CHANGE IN TRACK STRUCTURE

ATTACHMENT 5

**CALIFORNIA HIGH-SPEED TRAIN PROJECT
MERCED TO FRESNO**

TYPICAL SECTIONS
SHEET 5 OF 17

EL3 - DOUBLE TRACK ELEVATED ADJACENT TO UPRR/BNSF

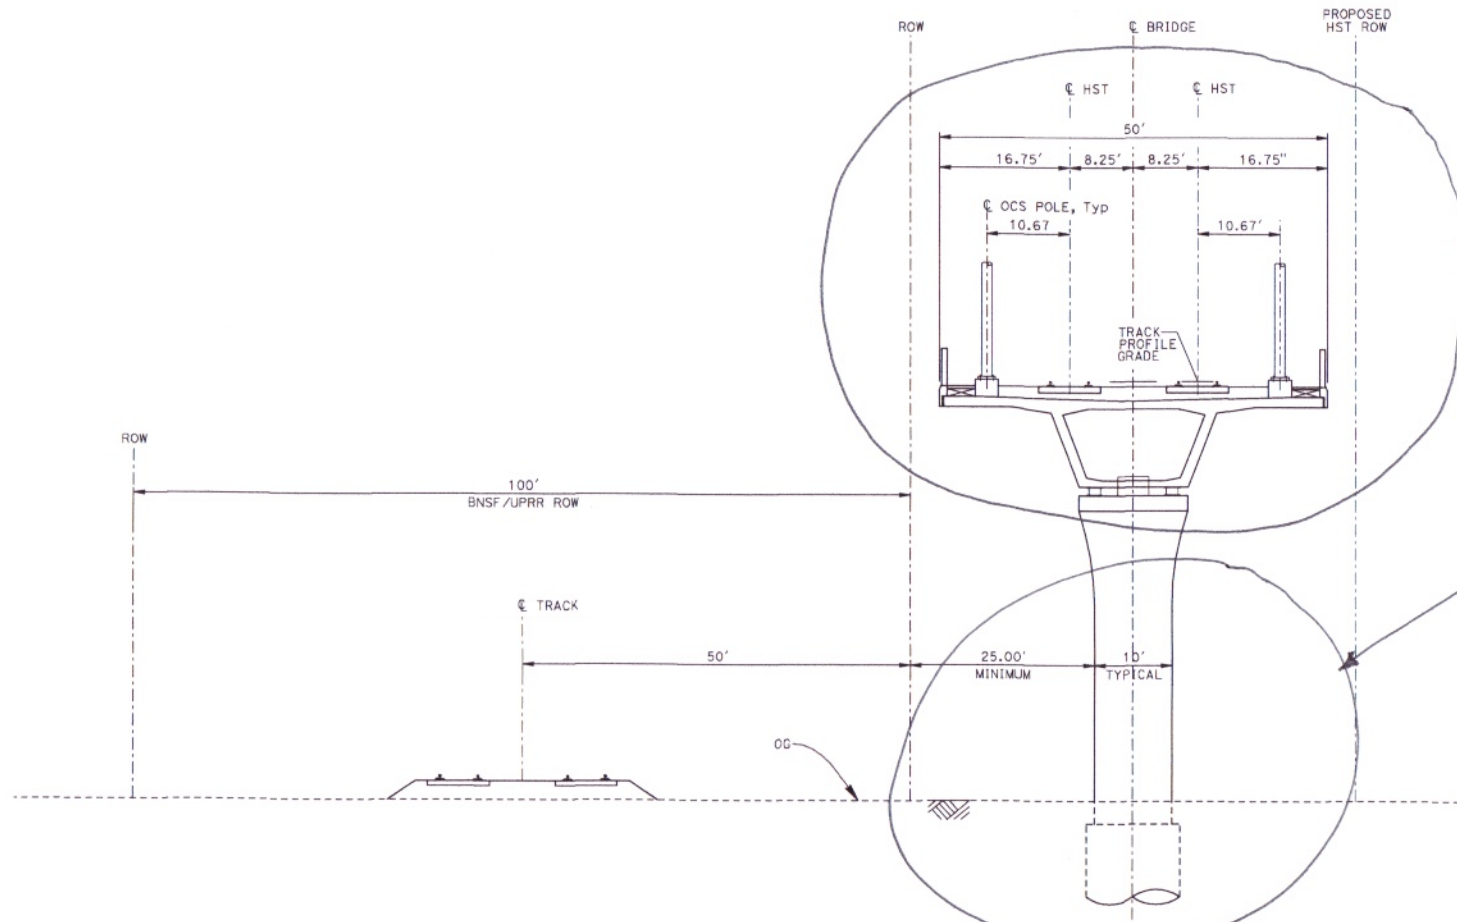
THE AERIAL DECK WILL NEED TO BE RE-DESIGNED TO ACCOMODATE ACCEPTABLE CURVATURE

THE COLUMN FOOTINGS MAY REQUIRE RE-LOCATION
